MODIFICATION REPORT: ARCHITECTURAL MODIFICATIONS TO SSD-10371

Prepared by Willowtree Planning Pty Ltd
on behalf of The Council of Trinity Grammar School c/-
Bloompark Pack PM

| Document Control Table | | | |
|----------------------------|---|--|---|
| Document Reference: | WTJ22-431 | | |

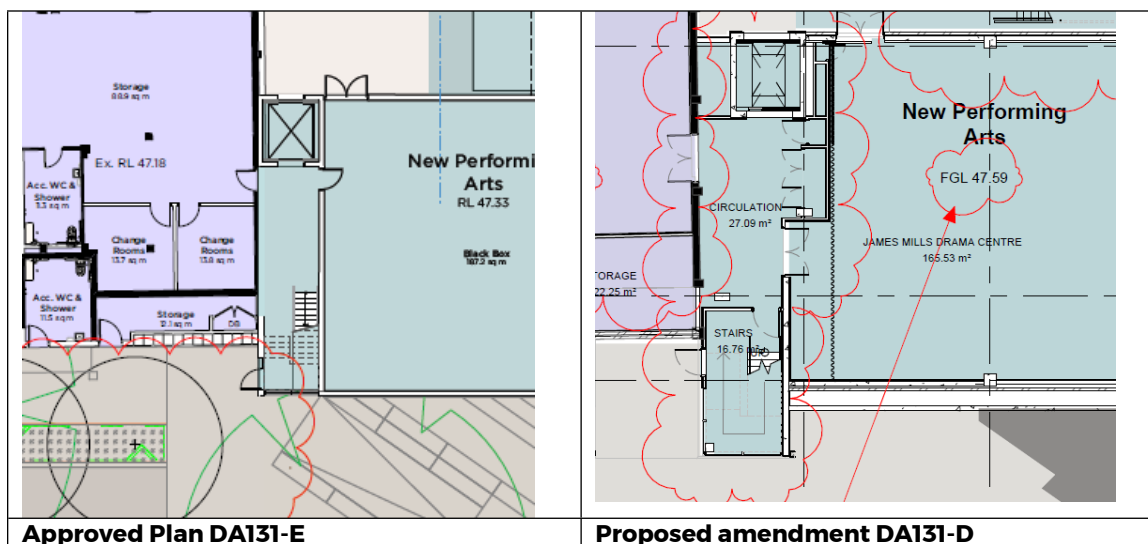
- It is proposed to change the plant enclosure from louvres as approved to panelised cladding to match the general typical cladding on this building. As the plant will draw all its outside air from above, an acoustically opaque screen can be used. Like the building cladding below this level will be recessive when viewed above the more prominent Arrow walkway screens.
- **Provide a compliant, fire isolated stair between the Music and Performing Arts buildings (refer 6-DA131).** To fire-isolate the stairwell and provide separate circulation between the two buildings on all levels, it is proposed to project the stairwell outside the building envelope 2.7m..

This would occur on all levels (refer 1/DA321/3 and 3- DA321/4) with the proposed glazed full height stairwell providing an elegant termination to the Performing Arts building where it abuts the existing Music building. It is noted that the proposed modification is in-keeping with the prevailing design of the existing building and by virtue of its location within the confines of the Site will have no material impact on the prevailing character or streetscene.

**Proposed Teaching and Learning Building Roof
Proposed Plan DA126-F**

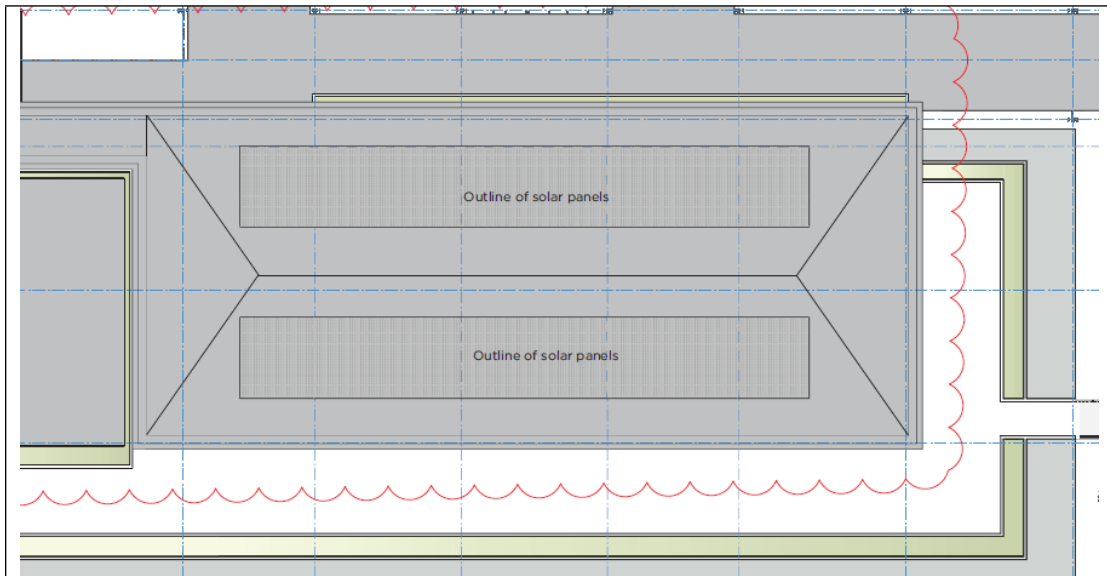
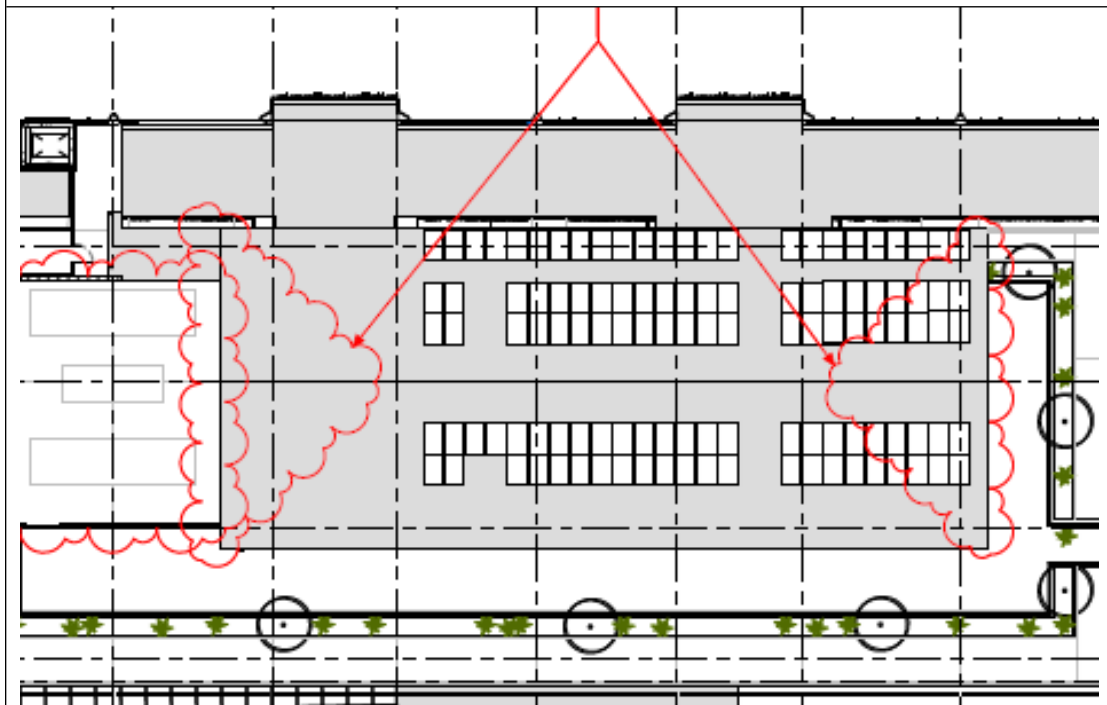
- **Amendment of hipped roof to gable roof.** It is proposed to remove the hipped ends from the main roof to improve head height below as hip structural members tend to be deeper and the hipped ends provide less height for ceiling plant. Head heights are severely constrained by the imposition of a reduced ridge height from RL 68.6 to 68.0 as required by deferred commencement condition

A1.1(iii). It is noted that RL 68.0 will still be maintained and there will be no increase in the ridge height of the roof. This amendment is proposed for NCC compliance.

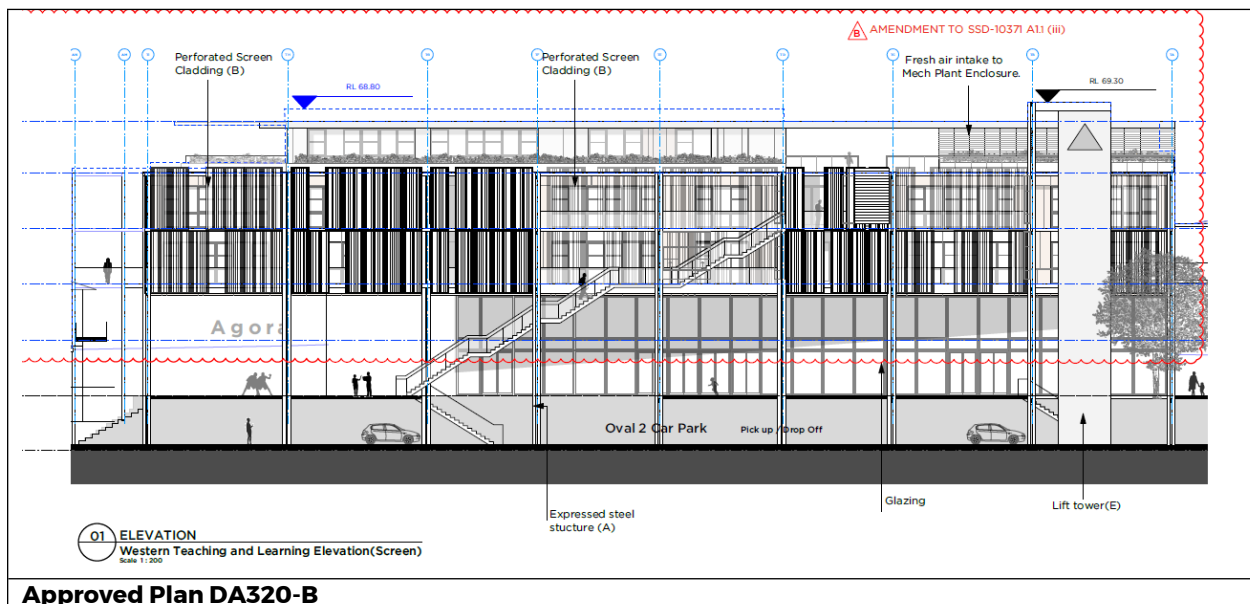
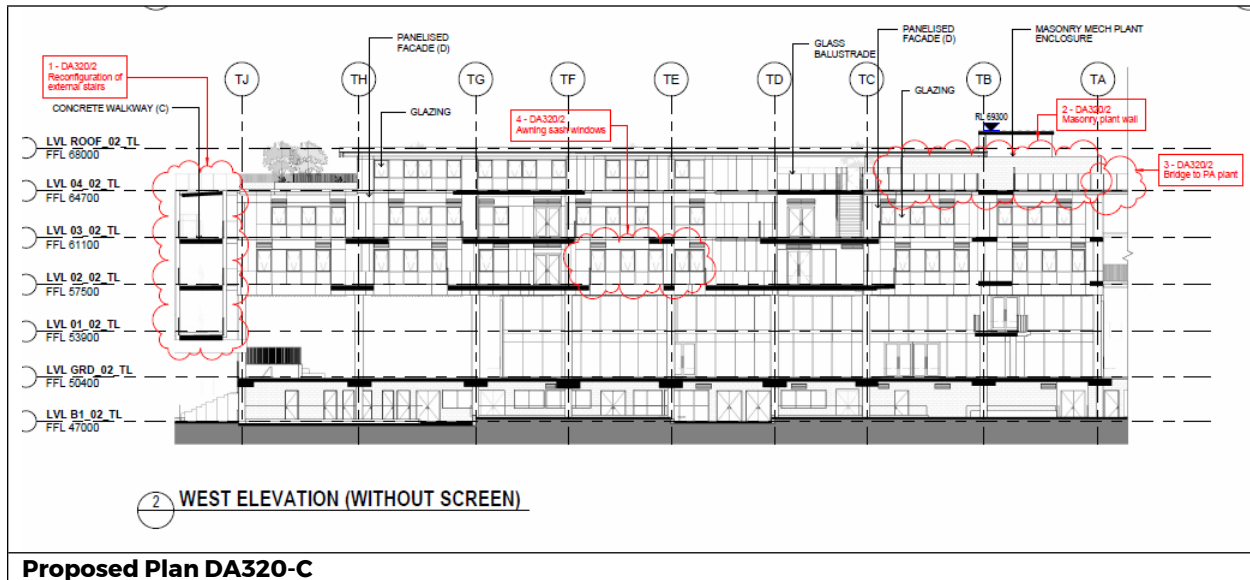
Alterations are proposed to the screen on the western elevation of the teaching and learning centre. The alterations seek to remove or relocate the western screen panels (refer DA320-321). The effect of these panels on the outside of the building has been considered together with those screens closer to the building façade for their combined effect on daylight, views and solar heat gain. The proposed configuration represents a rationalised arrangement of inner and outer screens. Some screens have also been added in response to further wind consultant advice that this would mitigate the adverse effect of western winds blowing between the Teaching and Learning and Performing Arts buildings (refer 5-DA320/1 and 11-DA321/1).

The screen prototype image (refer image B on DA320) is a direct development of the original SSDA concept (image B on DA320 B) – a perforated, undulating form in a warm ‘champagne’ colour. **No amendments are proposed to this concept, just the configuration of these screens within the Arrow building frame.** The east screen to the T&L building, above the Quadrangle building will be a similar material but with a flat profile as per the stamped elevation (refer 3/DA320).

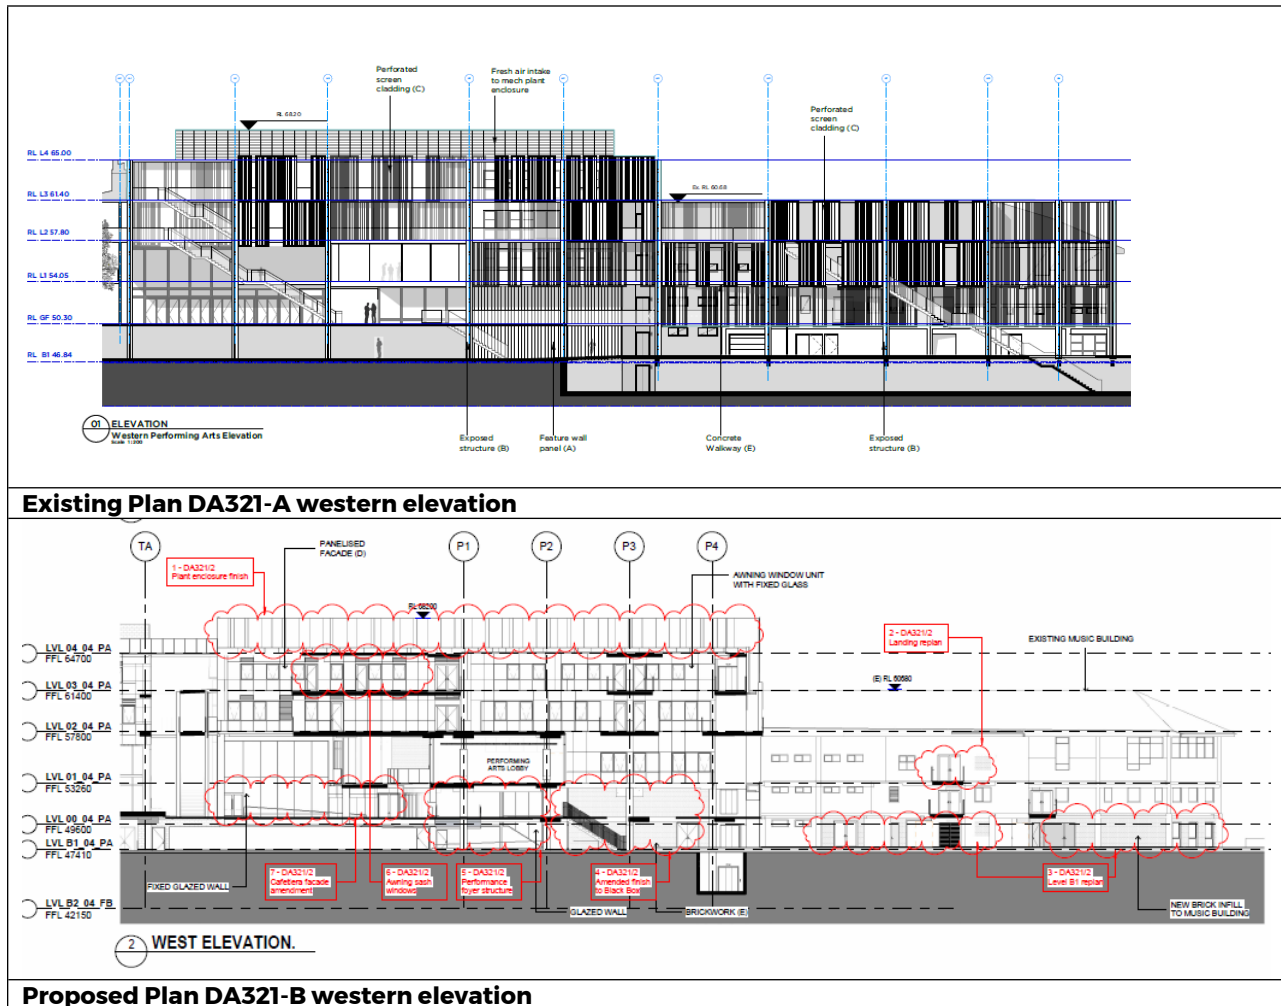
- **Cladding and louvres in lieu of high level windows.** It is proposed to replace the high level fixed glazing as approved with opaque cladding panels and louvres. Design development indicates that automated louvres at this level will be required for fresh air intake to the mechanical system and for natural ventilation when the space is not air conditioned.

- **Cladding above glazed openings**
- **Roof cowls above the parapet**
- **Amended cladding to the East elevation.** It is proposed to change the cladding material from a perforated metal screen to the typical panelised cladding system. A dark base band is not proposed on this side as the storey high recess to the carpark below provides a deep shadow above which the light upper façade will float. The cladding system ties in with the typical cladding language of the rest of the scheme and is bookended by face brick in the servery and amenities blocks.

Accordingly, the proposed amendments to the materiality of the building, comprising amendments to the southern façade of the Multi-Purpose Pavilion, seek to accord with principle 1 of Schedule 8 of the *Transport and Infrastructure SEPP* which relates to context, built form and landscape and principle 7 which seeks to ensure that school buildings and their landscape setting are aesthetically pleasing and respond to the positive elements of the Site and surrounding neighbourhood.

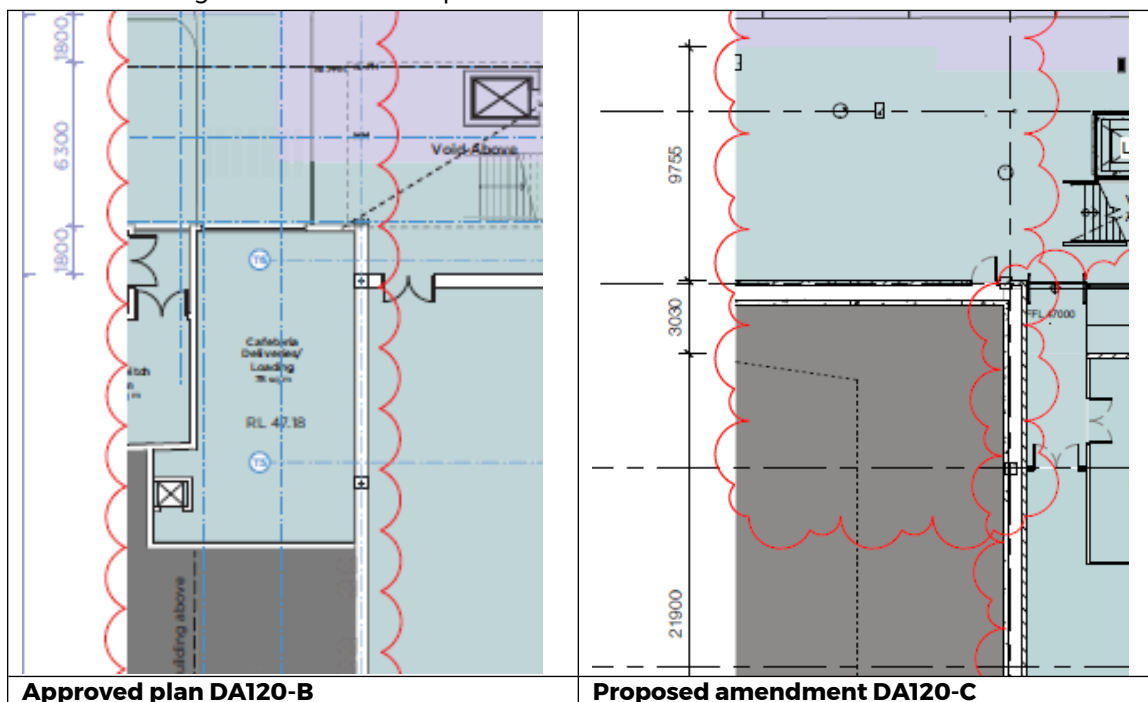
- **Extended plant area.** Design development indicates that a larger plant room than approved is required. It is proposed to extend this to the North as shown on plan (**refer to 2 – DA136**).

- **Cafeteria façade amendment.** The approved façade shows an openable wall to the cafeteria here. With the proposed replan of this precinct (refer 5 – DA132) this wall will abut an accessible ramp and the café will open up to the south instead. It is proposed that this wall is replaced with fixed glazing, double height glazing instead;

- **Plant enclosure finish.** It is proposed to change the plant enclosure from louvres as approved to panelised cladding to match the general typical cladding on this building. As the plant will draw all its outside air from above, an acoustically opaque screen can be used. Like the building cladding below this level will be recessive when viewed above the more prominent metal window screens;

Proposed Plan DA120-C

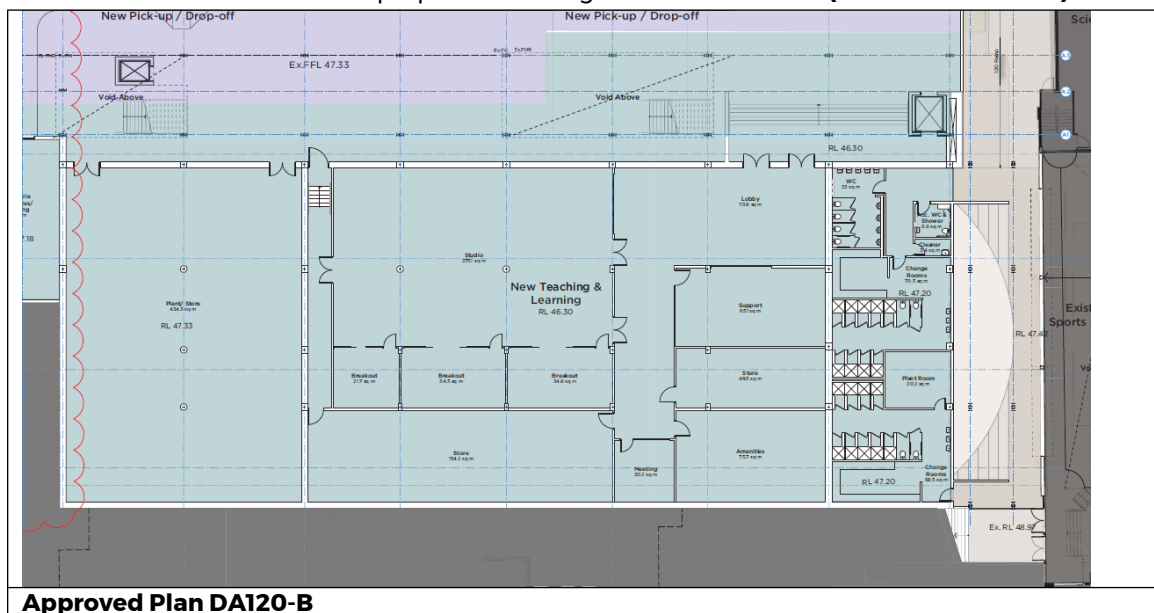
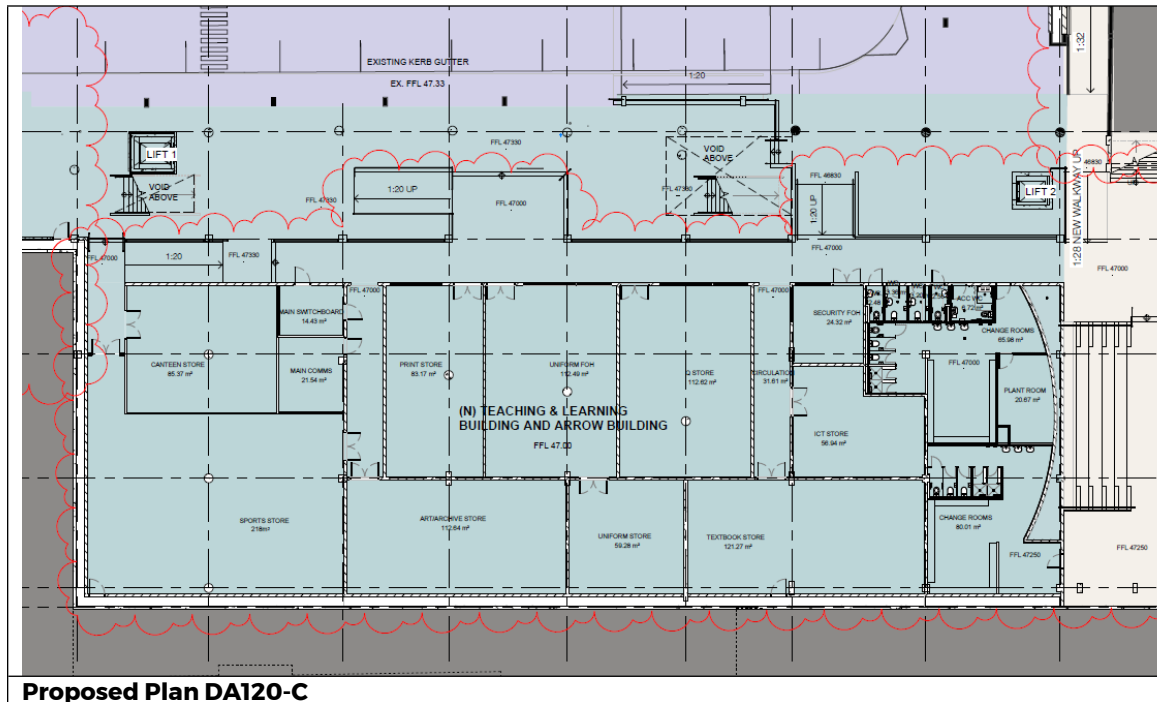
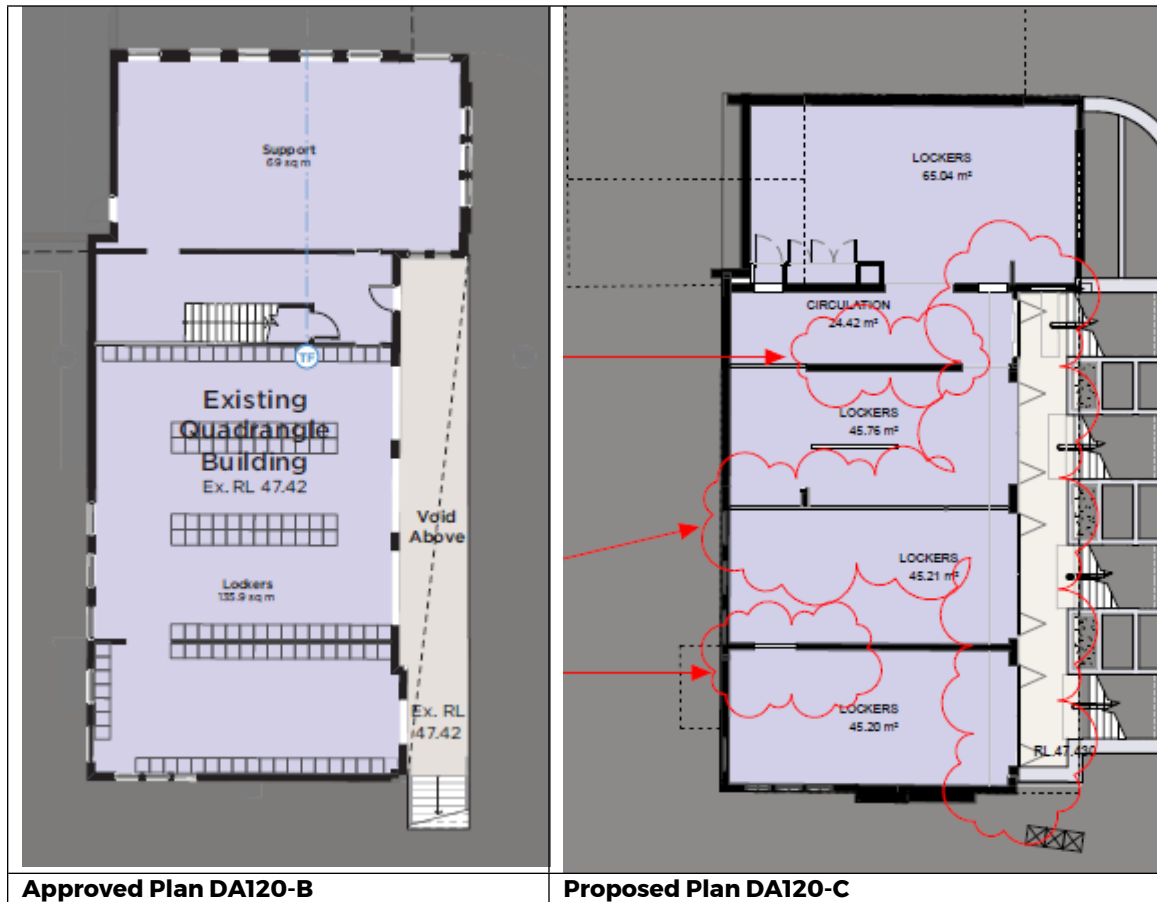
- Amendments to the Junior School Link.** New Accessible Walkway linking the Junior School with the main campus (part of the original SSDA – on PMDL drawing DA111 E). This has unearthed latent structures not readily apparent from existing documentation. This modification proposes adjustment to the plan and levels of the new link to this walkway to accommodate these latent conditions. This will be contained within the confines of the existing Site and will be of no environmental impact. Further details are included on proposed drawing reference **DA120-C (reference 2-DA120)**.

- General Basement replan.** The School has reviewed their operations on this level and consider that activities previously proposed for the approved Teaching and Learning studio can be accommodated in the new general learning spaces above. Accordingly, it is considered that this level, with direct access to the carpark is better suited for a Print Store, Uniform Store and ICT Store. Further details are included on proposed drawing reference **DA120-C (reference 3-DA120)**.

- **Locker Room replan.** Proposed amendments to the Quadrangle basement plan are in line with TGS' new campus-wide locker strategy. Further details are included on proposed drawing reference **DA120-C (reference 4-DA120)**.

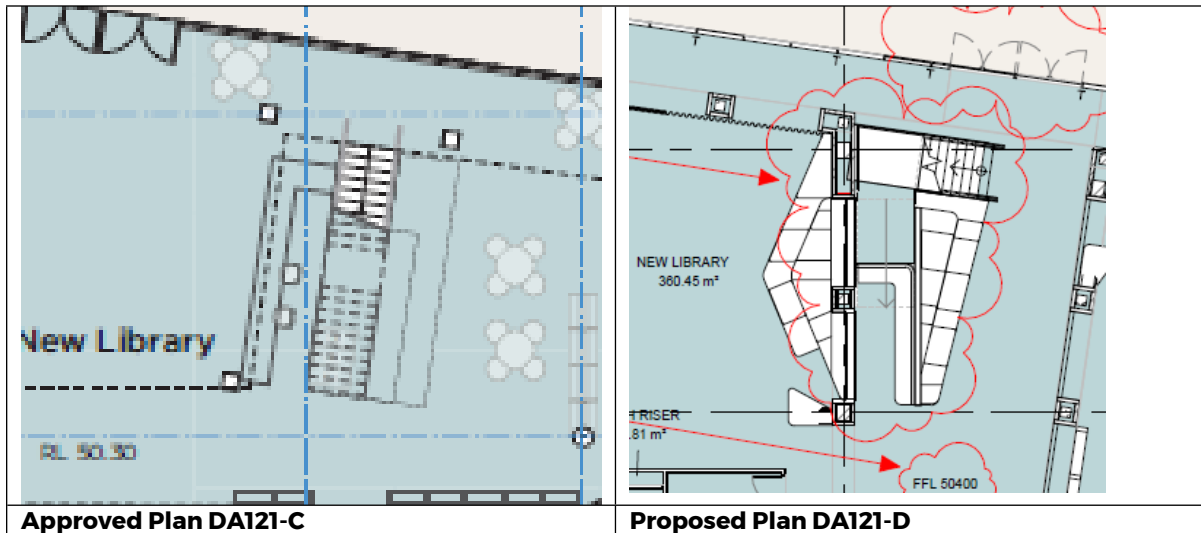
- Reconfiguration of Library entry doors. The relocated doors will be within the confines of the Site and not materially impact on the overall design and character of the extant approval;
- Pastoral area replan comprising reconfiguration internal walls. These works are internal to the building and will not impact on the overall design and character of the extant approval; and
- Replan of Library offices, Presentation Room, Reception back of house and Student Services. These works are internal to the building and will not impact on the overall design and character of the extant approval;

These amendments are contained within drawing reference **DA121-D** and set out in the accompanying design modification schedule produced by TKD (**Appendix 2**). These modifications are internal to the building and have no material environmental impact.
